Project/Equipment		-	
<div>BE-BI-OP</div> <div>CERN</div>	<div>VME FMC Carrier</div> <div>FMC Connector</div>	Designer	Andrea Boccardi
		Drawn by	Andrea Boccardi
		Check by	-
		Last Mod.	3/5/2010
		File	FmcConnector.SchDoc
		Print Date	3/11/2010 10:18:29 AM
European Organization for Nuclear Research		Sheet	- of -
		Size	A3
			Rev

Project/Equipment	-	Designer	Andrea Boccardi	XX/XX/XXXX
Document	-	Drawn by	Andrea Boccardi	-
Check by	-	Last Mod.	-	3/11/2010
File	PowerSupplies_SchDoc	Print Date	3/11/2010 10:18:30 AM	Sheet - of -
Rev	A2	Rev	-	-

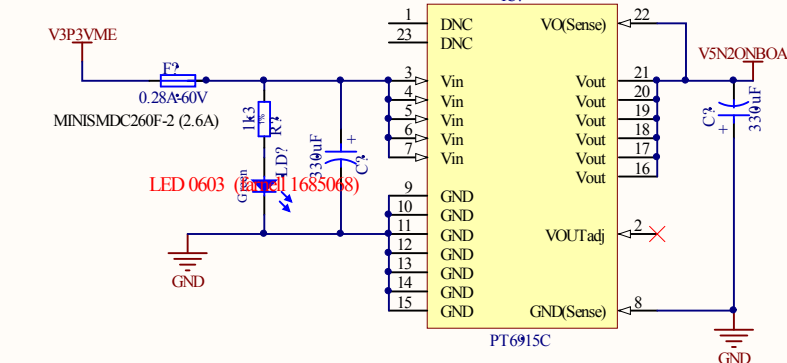
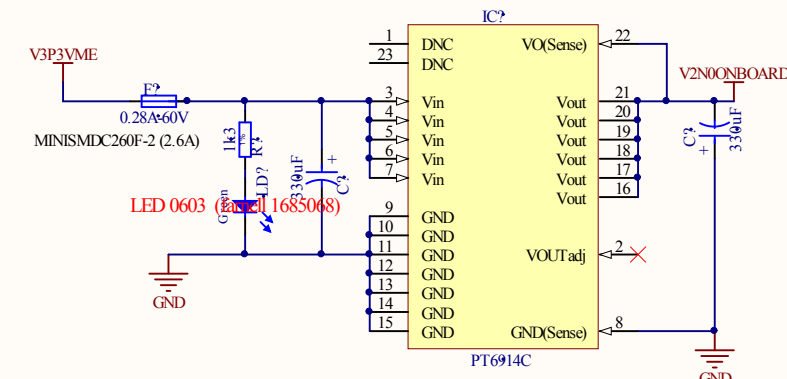
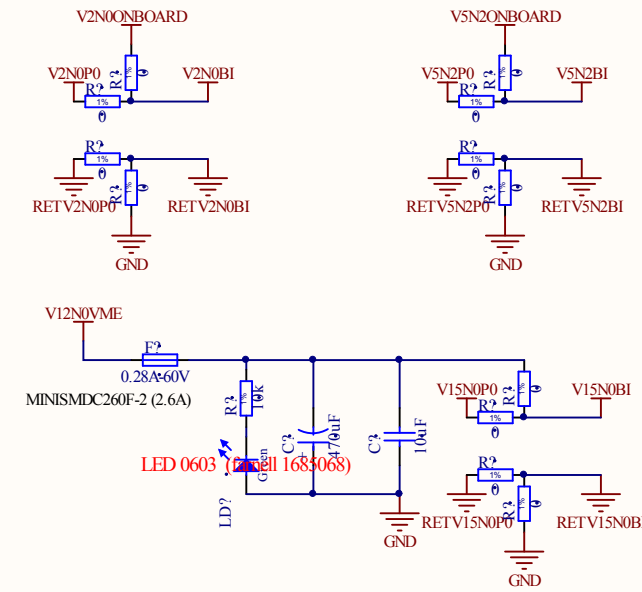
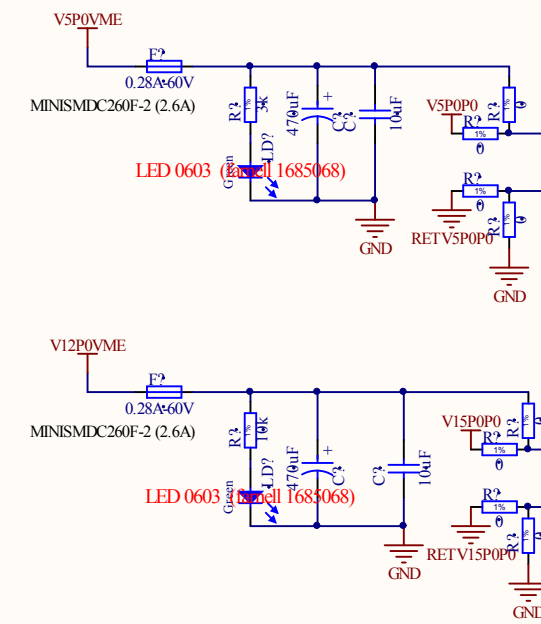
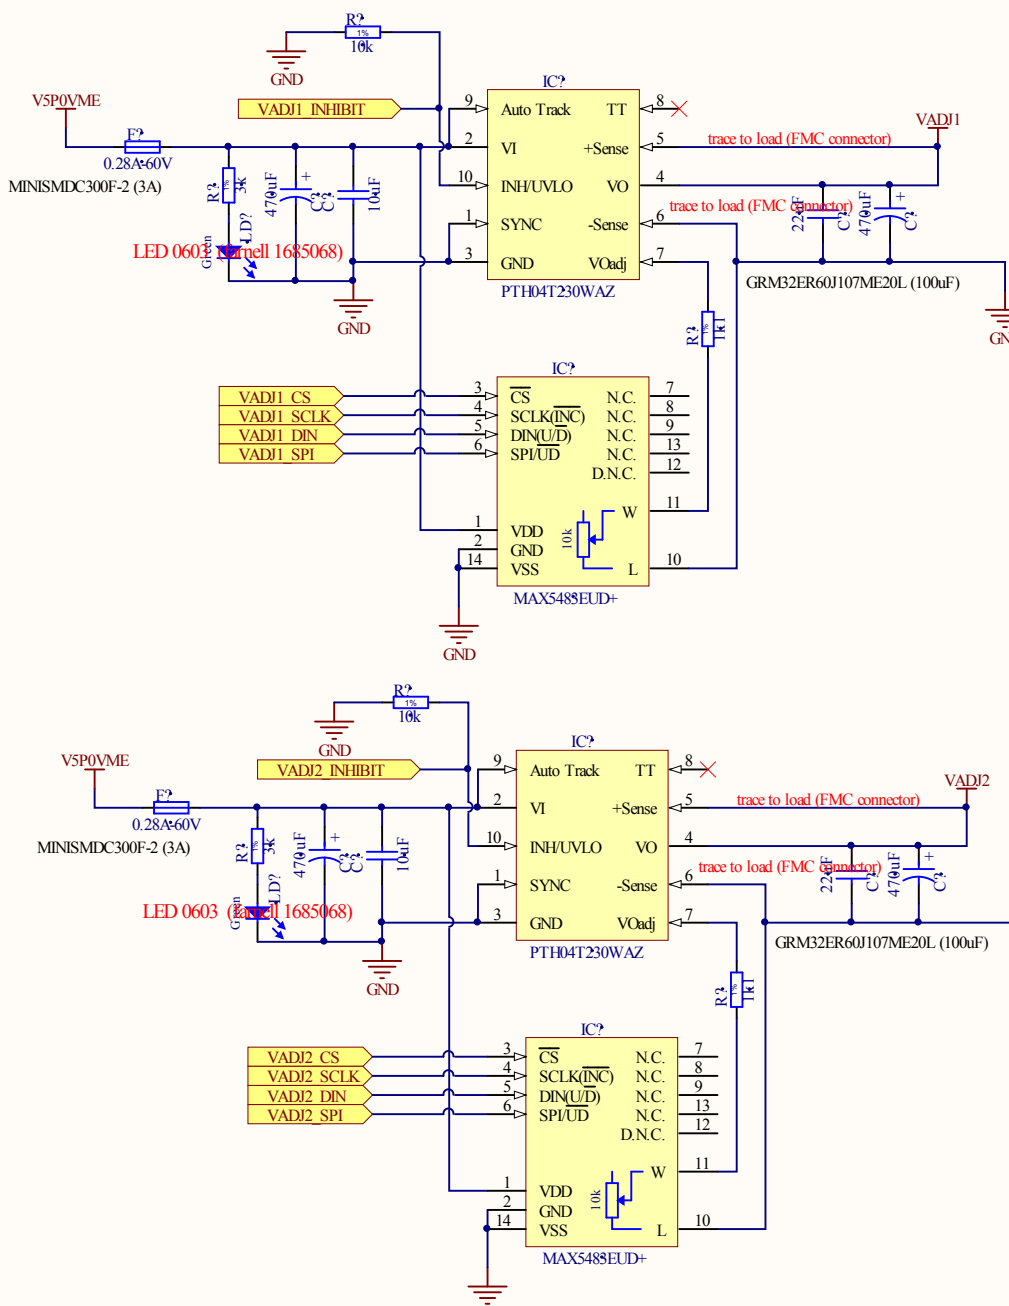
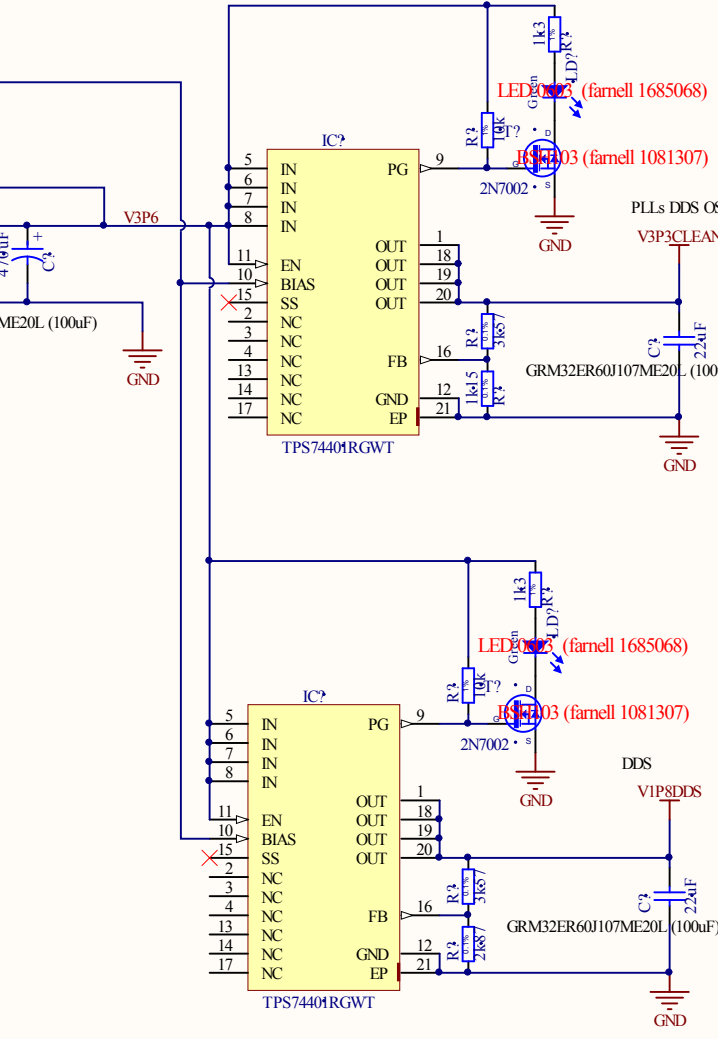
replace ALL the leds for ROHM - SML-311D TT86K - LED 0603 FAIBLE COURANT ORANGE (farnell 1685067)

EDA-XXXXX-VX-X

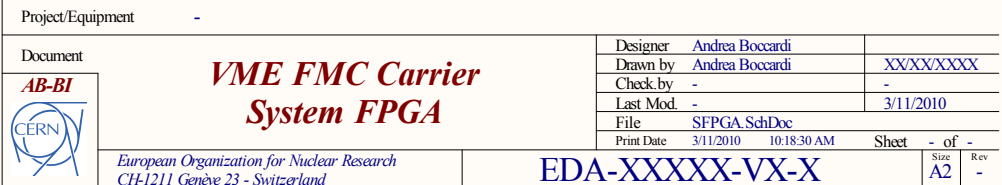
Replace with the 3V3 version (same pinout)
